**EXPLANATION OF SIGNIFICANT DIFFERENCES**

**SILRESIM CHEMICAL CORPORATION SUPERFUND SITE**

**LOWELL, MASSACHUSETTS**

**September 2008**

Figure 5 – Engineered Barrier Design Components

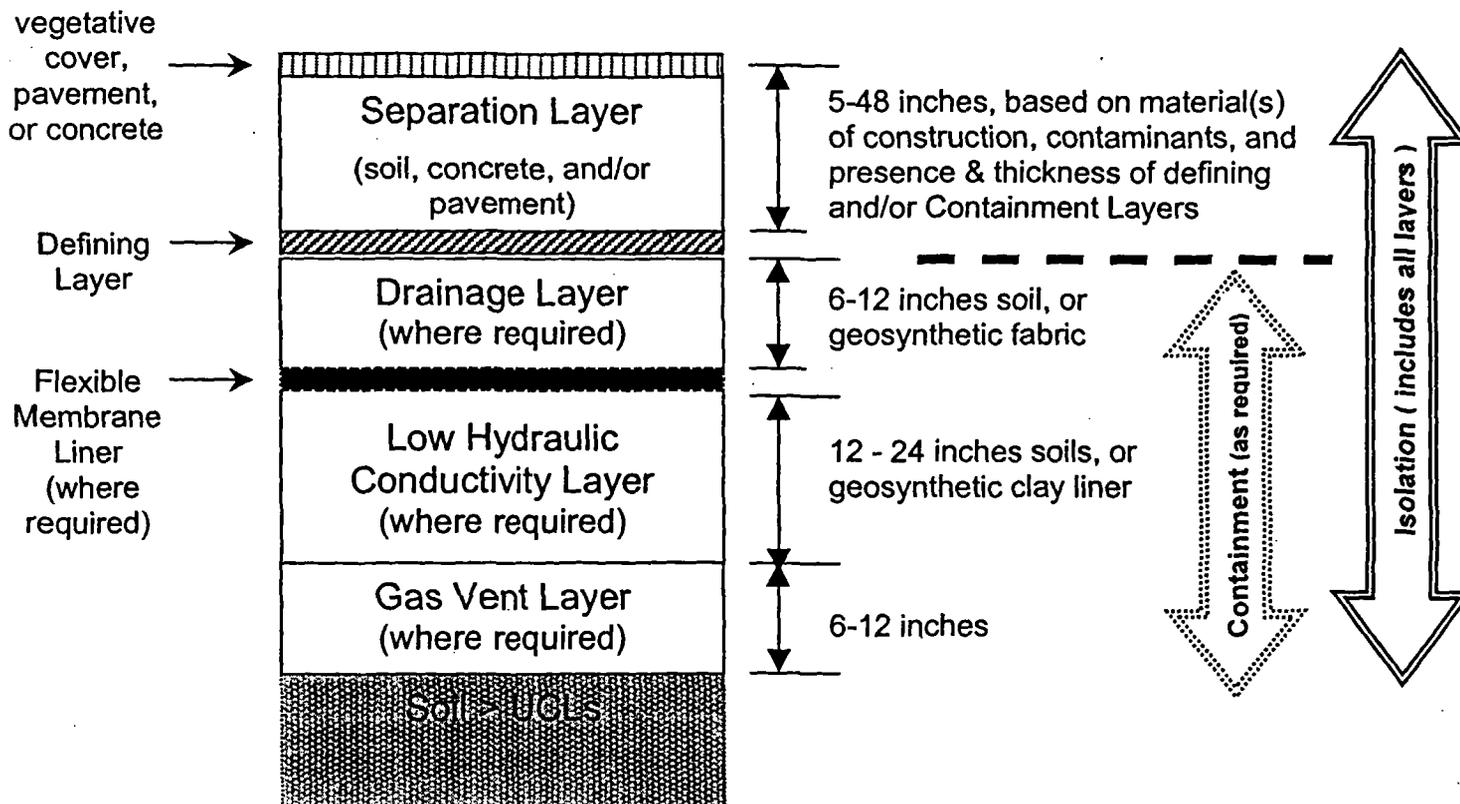
Both the EPA and MassDEP have reviewed the Commonwealth of Massachusetts Guidance on the Use, Design, Construction and Monitoring of Engineered Barriers and concluded it is protective for this site and allows some flexibility in meeting the performance standards required of a RCRA Subtitle C Hazardous Waste Landfill cap. Based on the guidance, an engineered barrier:

- Shall prevent direct contact with contaminated media;
- Shall control any vapors or dust emanating from contaminated media;
- Shall prevent erosion and infiltration of precipitation or run-off that could jeopardize the integrity of the barrier or result in contamination mobilization;
- Shall be constructed of materials that are resistant to degradation;
- Shall be consistent with technical standards of RCRA Subpart N, 40 CFR 264.300, 3120 CMR 30.6000 or equivalent standards
- Shall include a defining layer that visually identifies the beginning of the barrier;
- Shall be appropriately monitored and maintained to ensure the long-term integrity and performance of the barrier; and
- Shall not include an existing building, structure or cover material unless it was designed to serve as an engineered barrier.

Among these criteria, is the requirement that any final cover must provide long-term minimization of migration of liquids through a landfill. Based on the assessment of the existing cap, it was concluded that the existing low permeable clay layer on the property provides the necessary contaminant migration control required by this performance criterion. The additional reduction afforded by the stabilization is not necessary to prohibit contaminant migration. Thus, EPA is eliminating the need for additional treatment by stabilization as part of the remedy. Also, EPA is re-affirming the previous TSCA waivers (in the 1991 ROD) notwithstanding the elimination of the stabilization requirement. In addition, other cap improvements are expected to be incorporated into the remedy including increasing the thickness of the containment layer and adding a more visible marker layer in the area of the property most likely to be redeveloped. This parcel is referred to as Conceptual Parcel 2 on Figure 4.
